UNITED STATES PATENT AND TRADEMARK OFFICE

APPLICATION NO.	FILING DATE	FIRST NAMED INVENTOR	ATTORNEY DOCKET NO.	CONFIRMATION NO.
09/806,738	05/29/2001	Pieter Hendrik Albert Venemans	01100/LH	5982

Office Action Summary

DETAILED ACTION

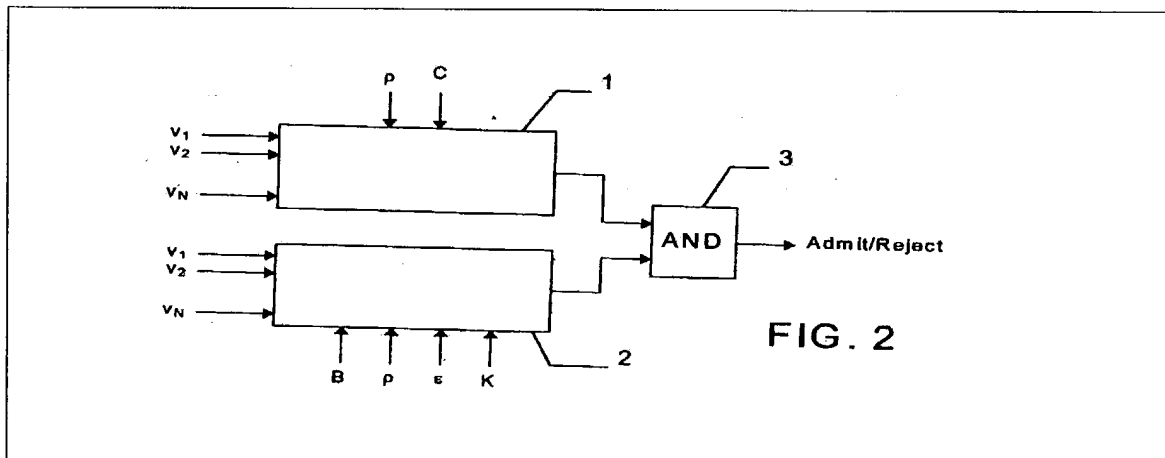
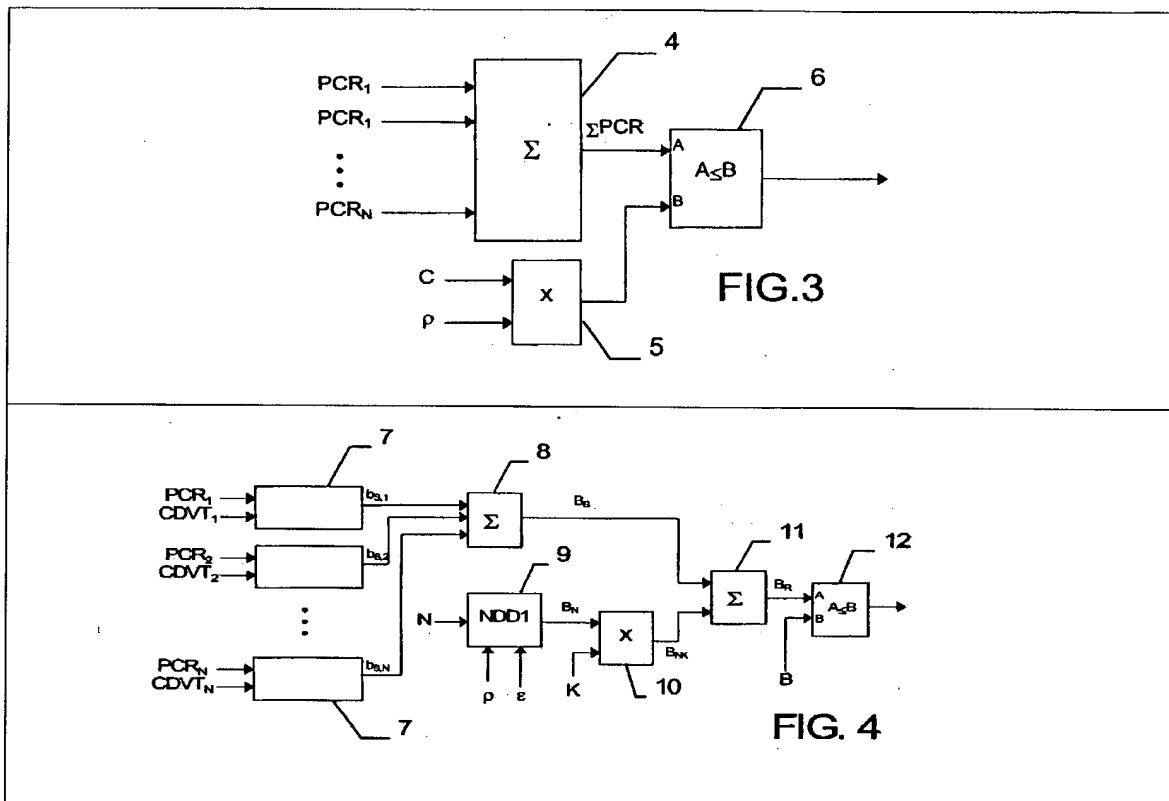
However, None of the prior art of record taken singularly or in combination taught or suggested a CAC device comprising to sub-devices (See Figure 2) each generating a positive or negative result and granting/admitting a connection request to the ATM switch only when both sub-devices issue a positive signal, the first sub-device device comprising two arithmetic units and a second sub-device comprising multiple arithmetic units each calculating and comparing specific values of the parameters related in determining admittance of a connection request to the ATM switch where the first device comprising two arithmetic units, arithmetic units one calculating sum of the nominal traffic parameters Peak Cell Rate (ΣPCR) of each ATM connections and second arithmetic unit comparing the computed sum (ΣPCR) with a value $\rho \times C$, where C is a capacity at an output port and ρ is a constant ($0 < \rho < 1$) corresponding to a desired maximum load (See Figure 3) a second sub-device comprising multiple arithmetic units (arithmetic units 3-7) and a comparison device (reference # 12 in Figure 4), where the third arithmetic unit (reference # 7 in Figure 4) calculates "a buffer capacity $b_{s,i}$, the value of $b_{s,i}$ being equal to zero if the product of the nominal Peak Cell Rate (PCR_i) and Cell Delay Variation Tolerance ($CDVT_i$) of the related connection is less than or equal to a constant K , and the value of $b_{s,i}$ being equal to said product minus the value of K if the product is greater than K ", a forth arithmetic unit (reference # 8 in Figure 4) computing the sum of the calculated values $b_{s,i}$ for all ATM connections at a related output port, a fifth arithmetic unit (reference # 9 in Figure 4) calculating a buffer capacity B_N , "such that upon multiplexing of N independent, identical and ideal ($CDVT = 0$) traffic streams, using a single buffer with a buffer capacity of B_N , and assuming a

maximum link load having a value of ρ , the average probability of cell loss as a result of buffer overflow will not exceed a given value of ϵ ," a sixth arithmetic unit (reference # 10 in Figure 4) which calculates a product (B_{NK}) of the value of B_N and the constant value K ; a seventh arithmetic unit (reference # 11 in Figure 4) which determines the sum (B_R) of the calculated values for B_S and B_{NK} ; and a comparison device (reference # 12 in Figure 4) which compares the calculated sum B_R with the given capacity B of the output buffer, a positive admission signal being emitted if the value of B_R is less than or equal to B , and a negative admission signal being emitted if the value of B_R is greater than B . The claimed invention is supported by the specification of the application (See Figures 2-4 below and Page 6, Line17 through Page 9, Line17).
